RESOLUTION NO. 2016-26

Final Winter and Company Analysis and Testing of Proposed Development Code Report

DRAFT ZONING CODE

ANALYSIS AND TESTING

ONE-STORY COMMERCIAL OFFICE ADDITION

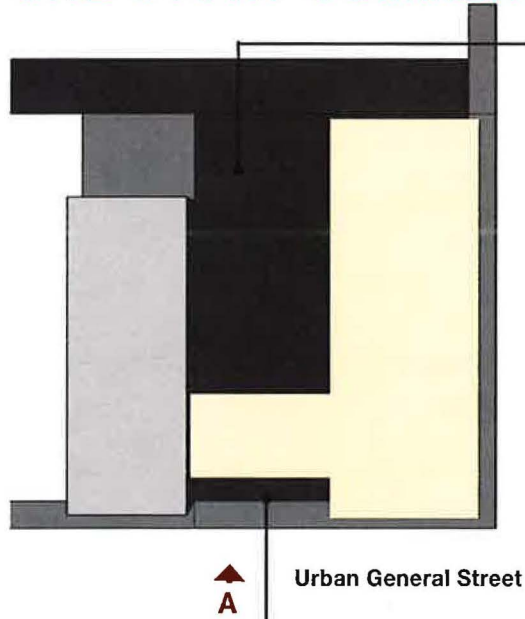
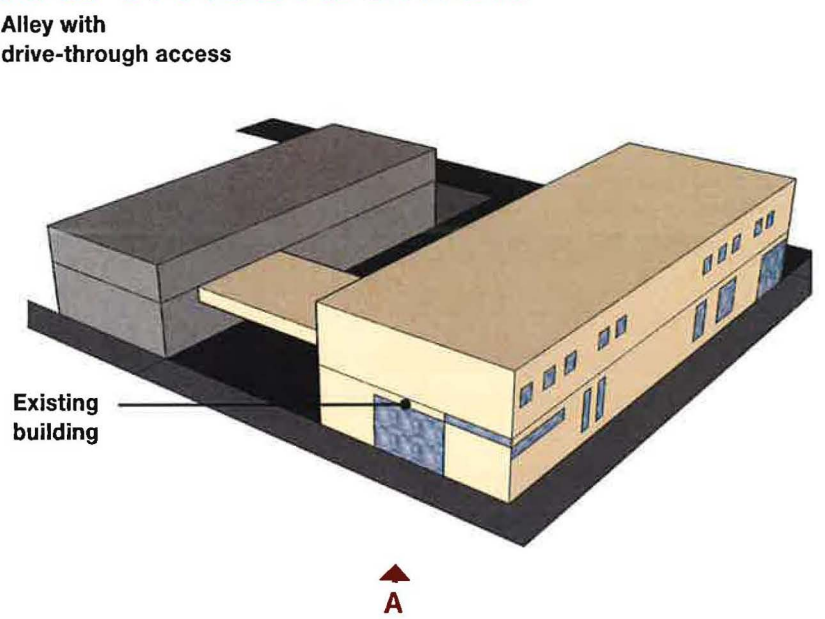
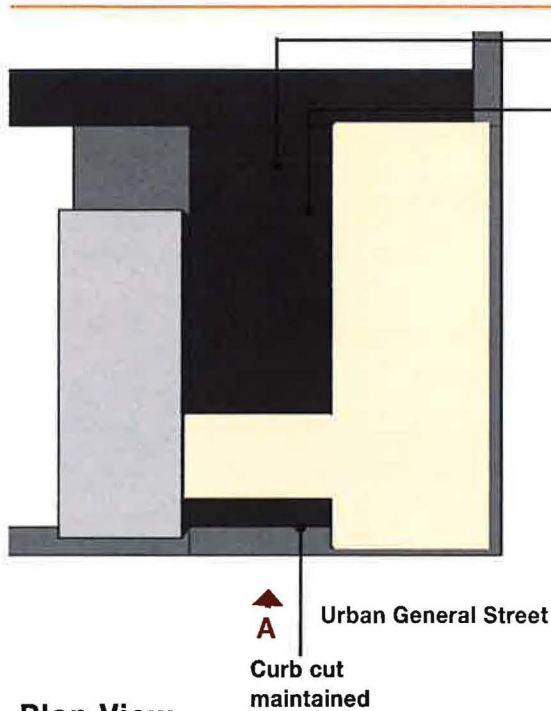
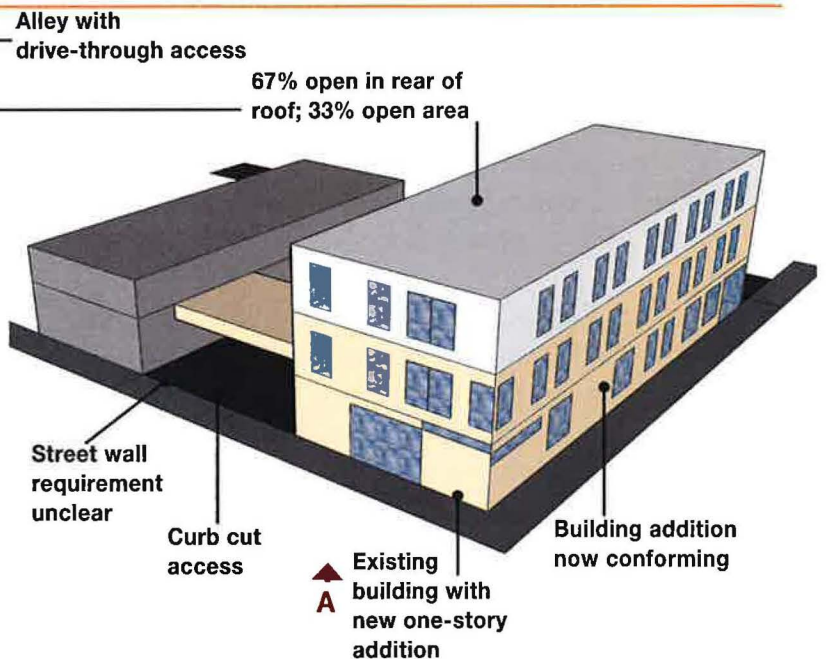
Standards Tested:

- **Parking setback area** - no issues anticipated
- **Open area requirement** - no issues anticipated
- **Street wall requirement** - possible issues due to maintaining of curb cut access onto street
- **Curb cuts/Street access** - issues unclear due to clarity of code and review process
- **Maximum development area** - no issues anticipated
- **Facade articulation & Fenestration** - no issues anticipated beyond clarity of code provision
- **Required Build-To Line** - does not conform with standard 75% build-to requirement

- Curb cut requirements and process are unclear and may affect development
- Ground floor open area doubles as drive through access area
- Fails to meet an 9% return on asset
